IN THE MATTER OF ADOPTING)
THE 2006 EDITION OF THE)
INTERNATIONAL RESIDENTIAL)
CODE)

RESOLUTION NO. R-10-0053

INTERNATIONAL RESIDENTIAL CODE

LINCOLN RESIDENTIAL BUILDING CODE

FIGURE R307.1
MINIMUM FIXTURE CLEARANCES

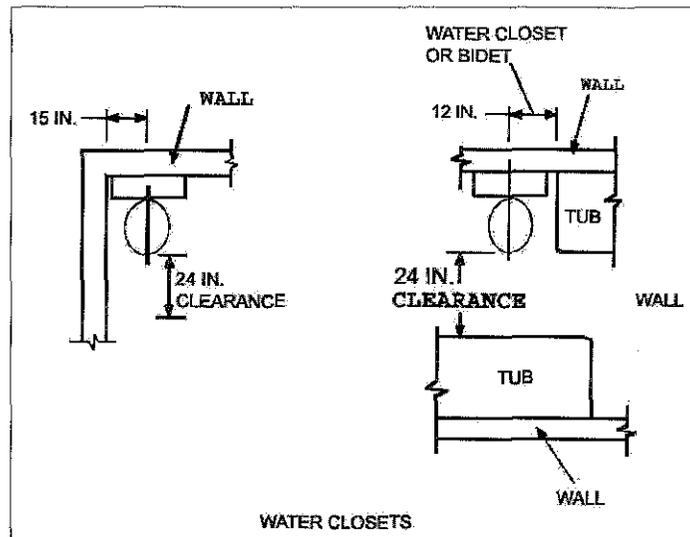
20.10.270 Figure R307.1 Amended; Minimum Fixture Clearances.

Figure R307.1 of the International Residential Code is amended to read as follows:

*FIGURE 403.1(1) MINIMUM FOOTING REINFORCEMENT

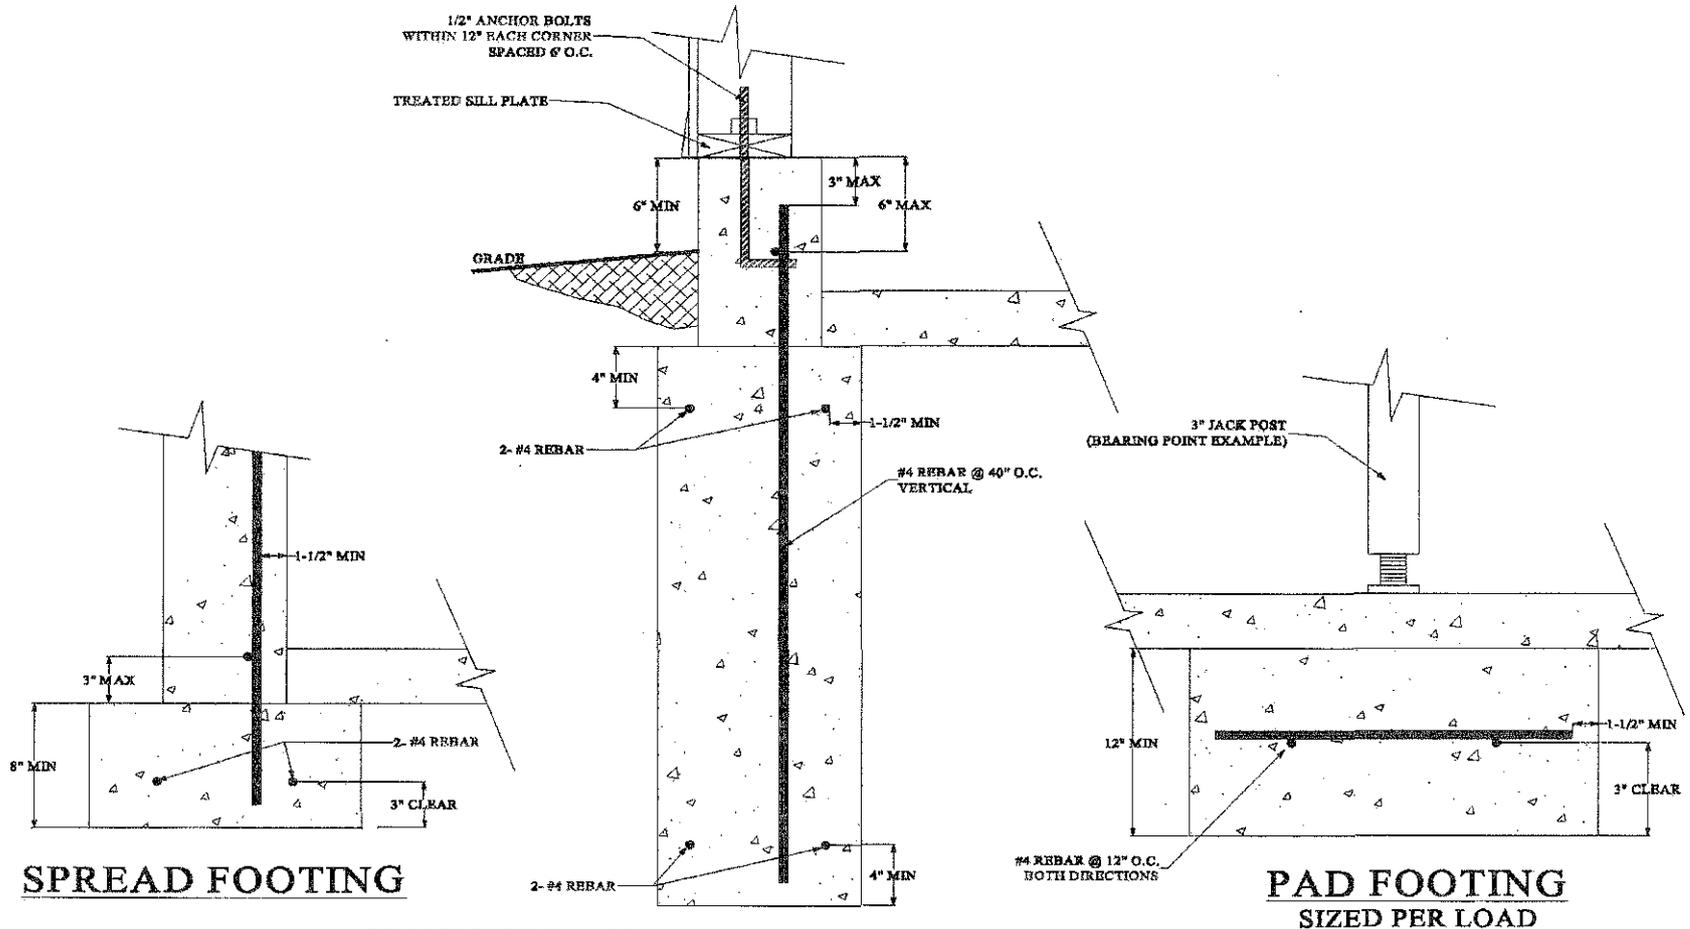
20.10.466	Table R403.1 Amended; Minimum Width of Footings.
20.10.467	Figures 403.1(1), 403.1(2) and 403.1(3) Amended; Footings.
20.10.468	Section R403.1.4.1 Amended; Frost Protection.

***FIGURE 404.1.1(5)**
8" PERMANENT POURED DAYLIGHT
BASEMENT WALL SECTION(4' MAX HEIGHT)

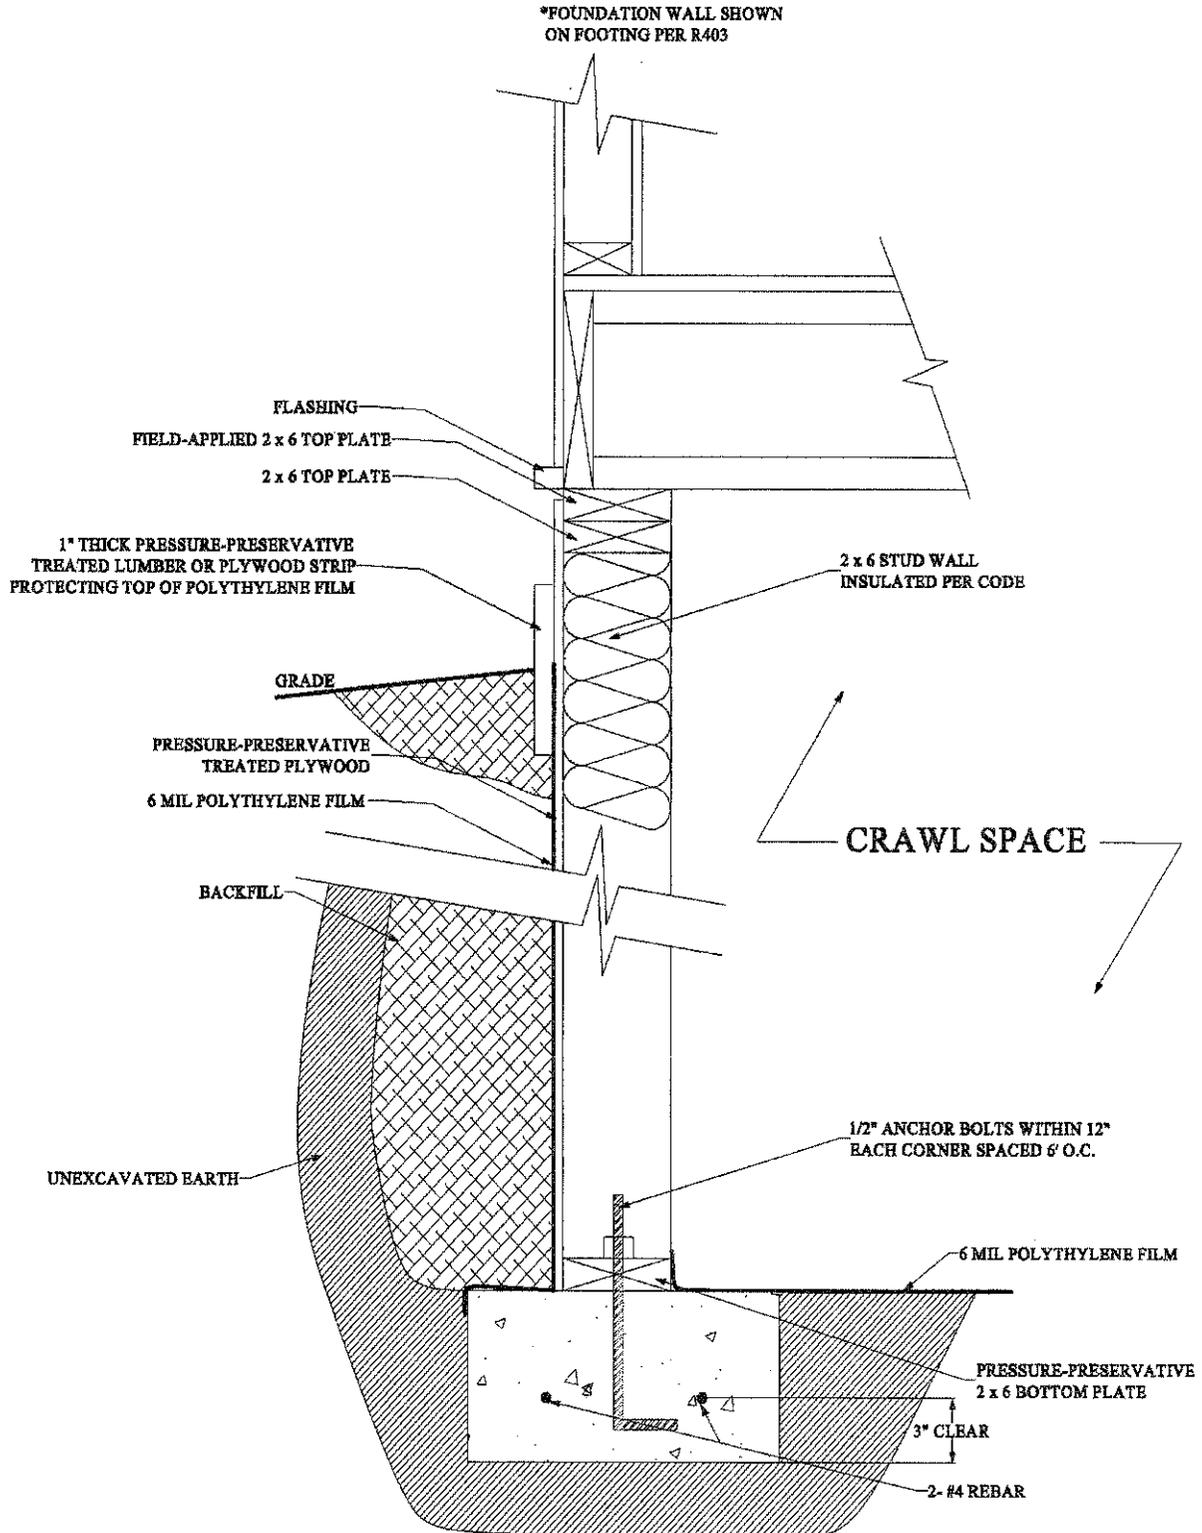
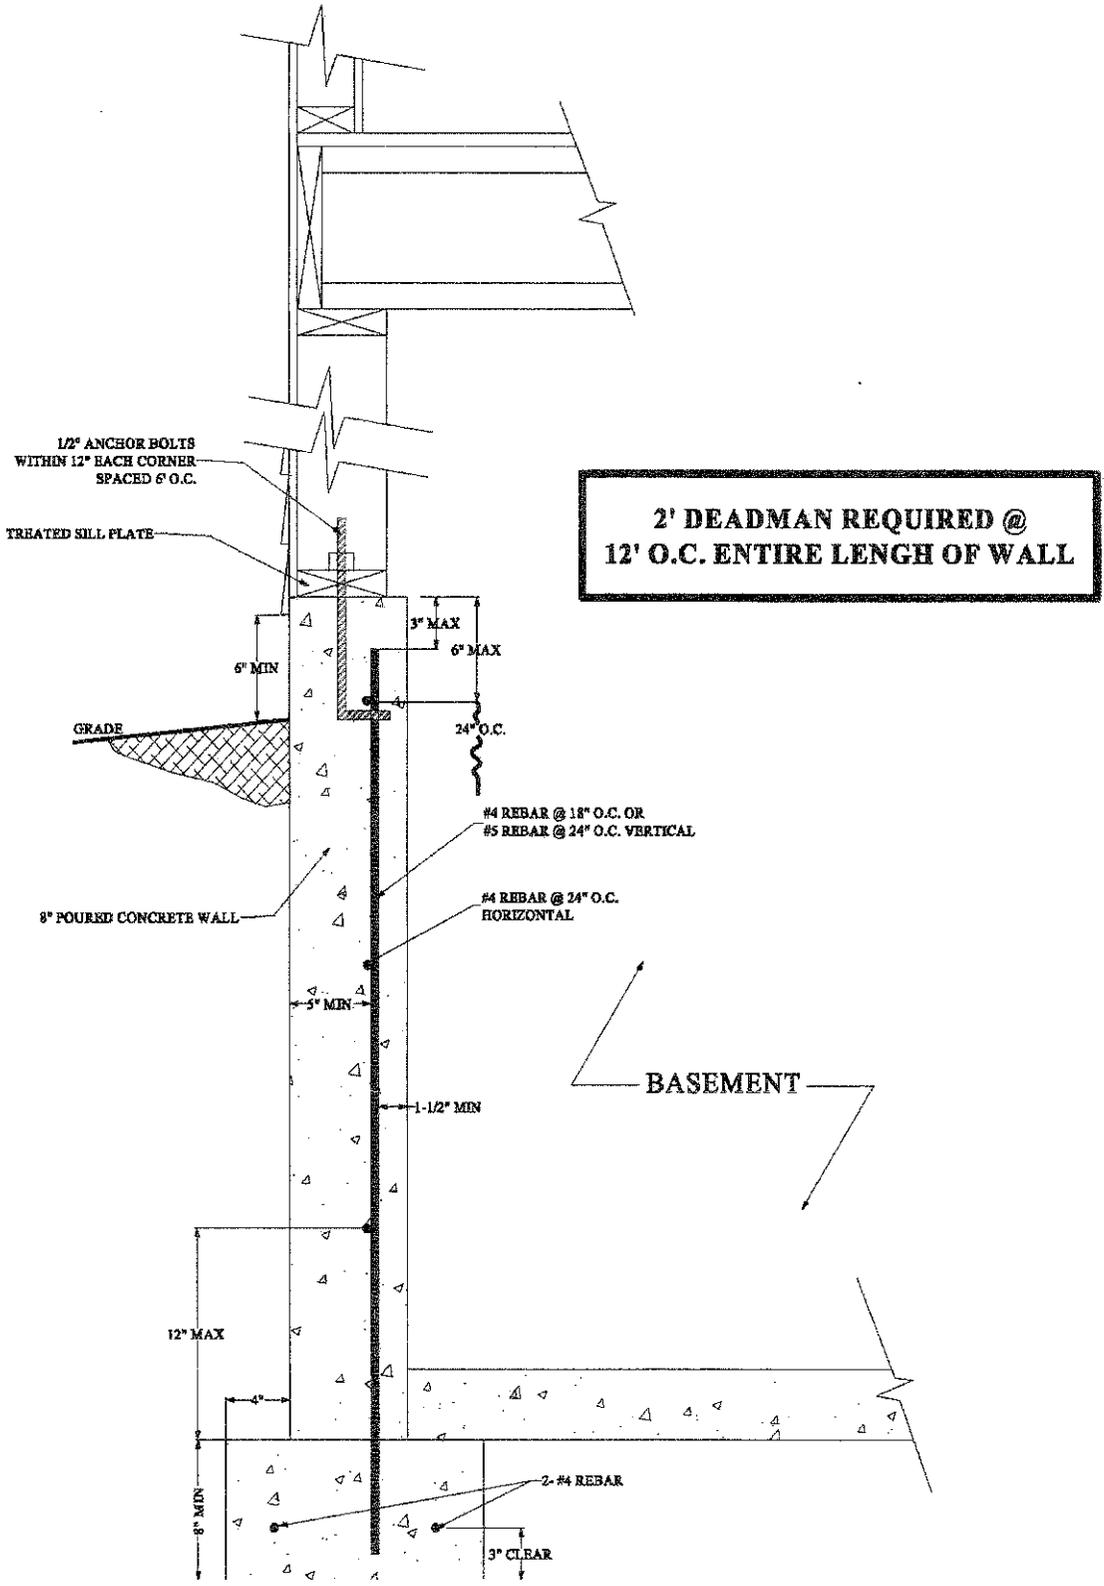
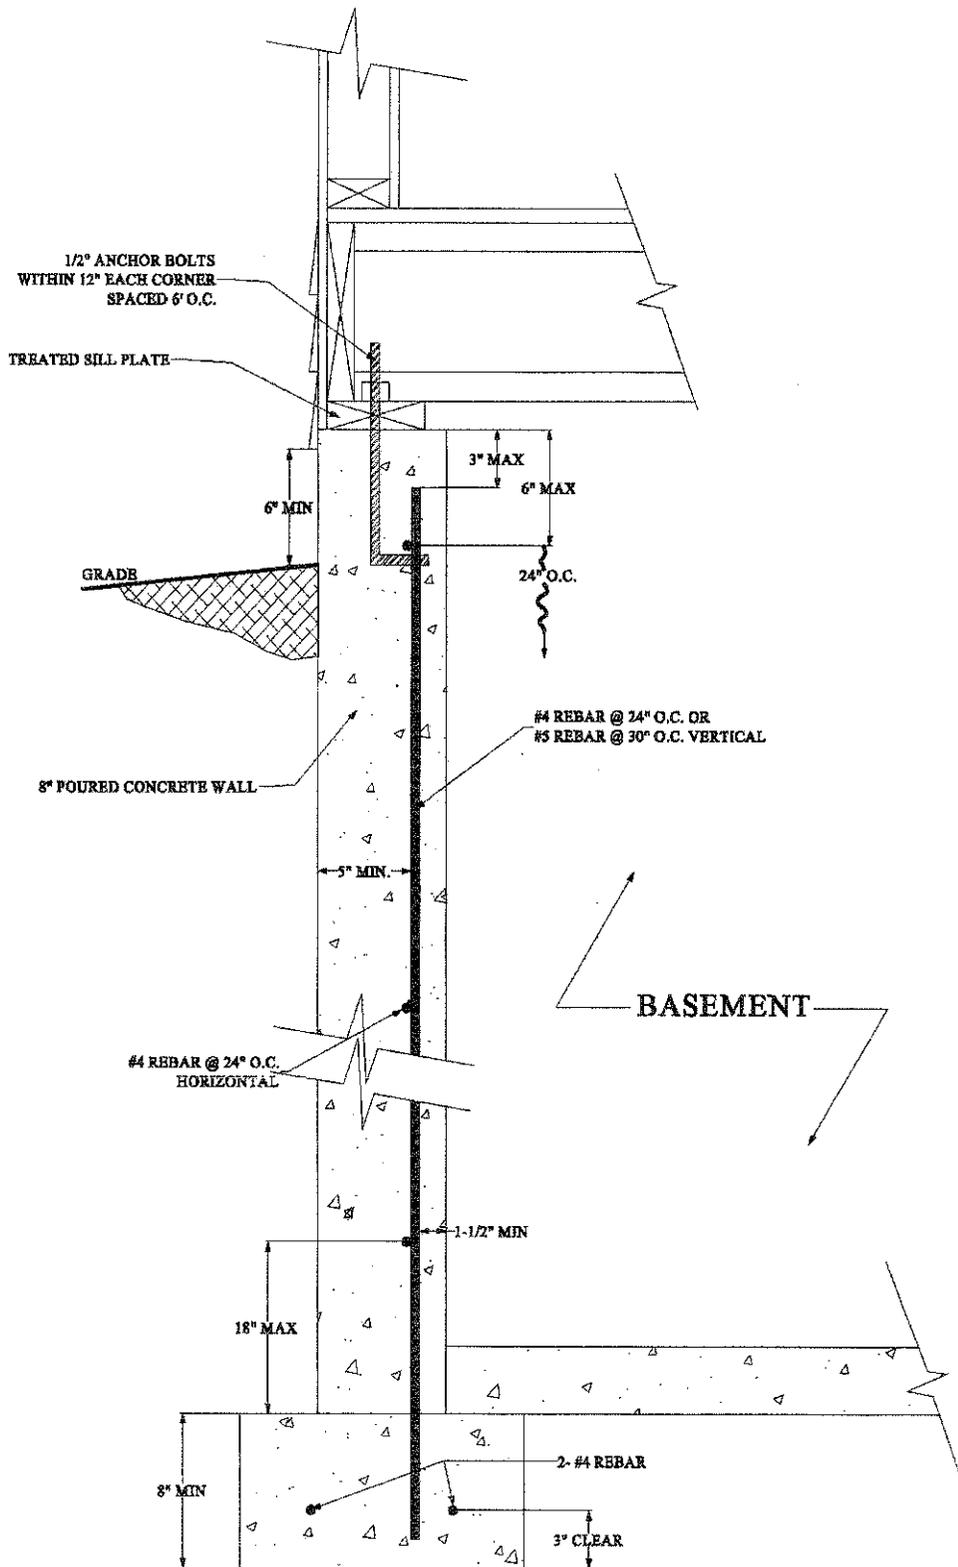
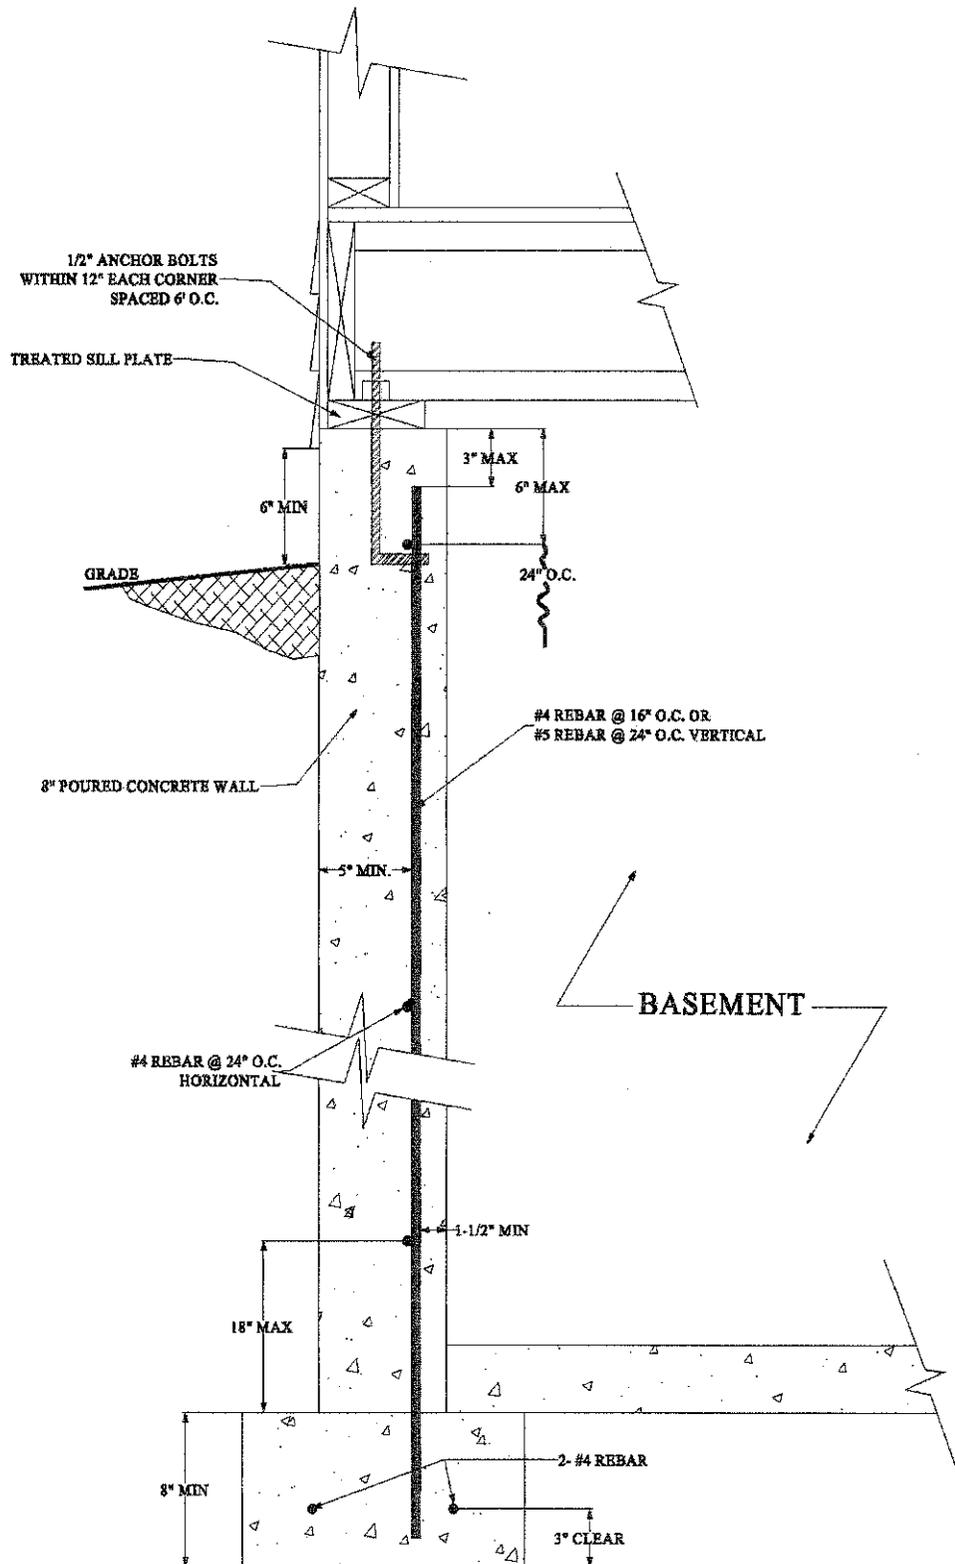
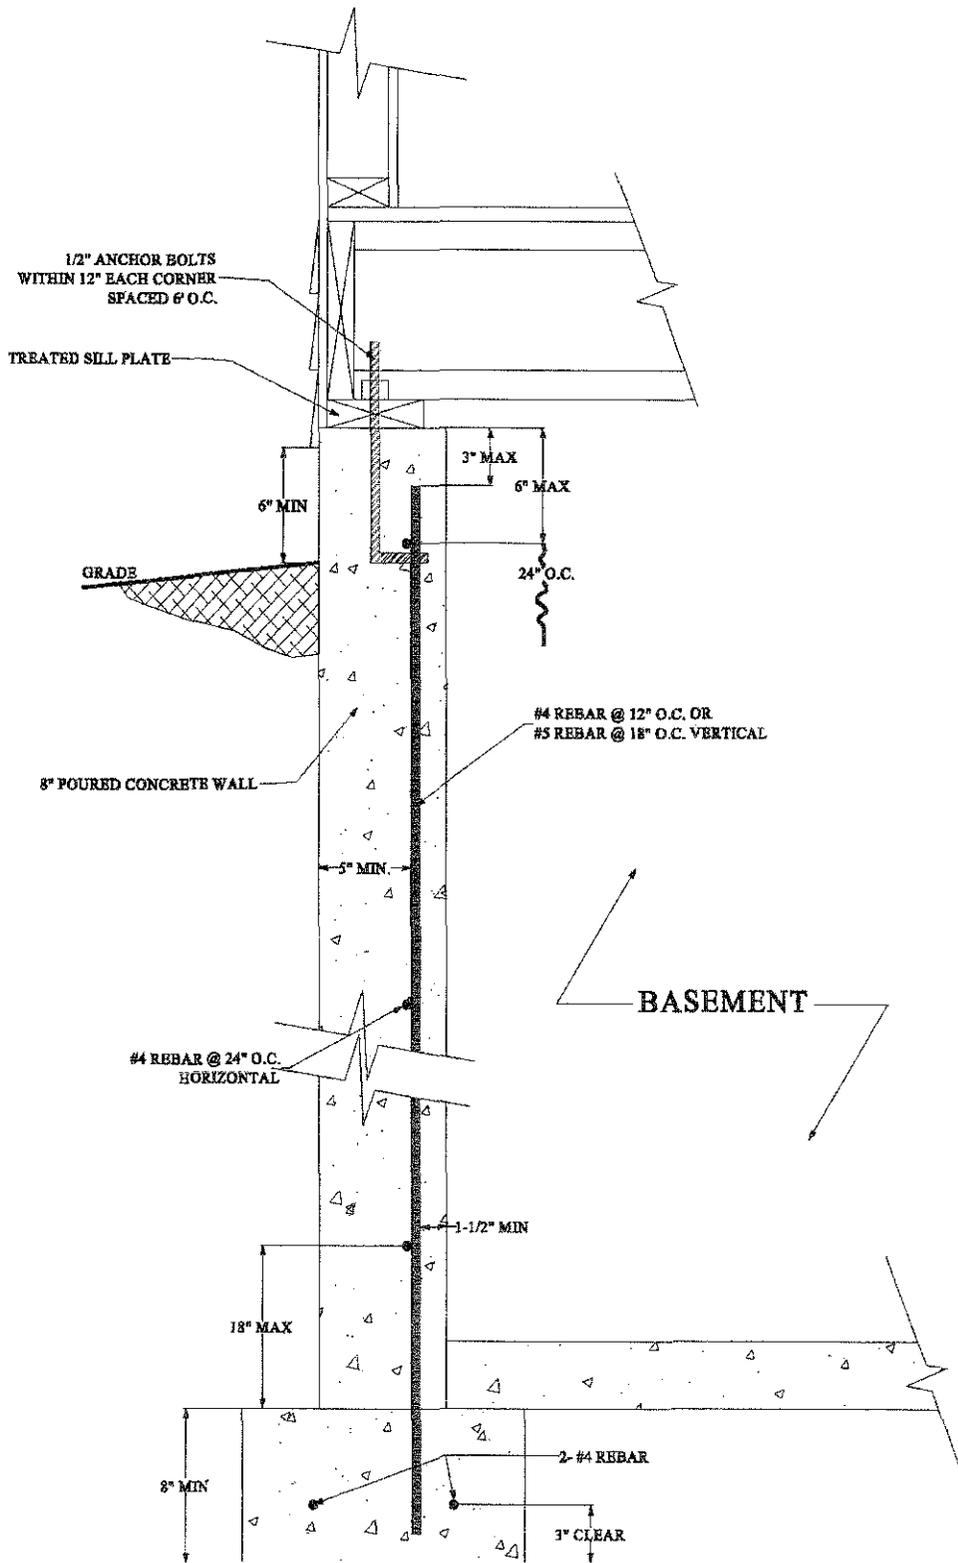
20.10.475 Table R404.1.1(5) Deleted; Figure R404.1.1(5) Added; Minimum Reinforcement; Residential Poured Walls.

Table R404.1.1(5) of the International Residential Code is hereby deleted and replaced with Figure R404.1.1(5) as shown on said figure at the end of this chapter. (Ord. 19033 §54; January 7, 2008).
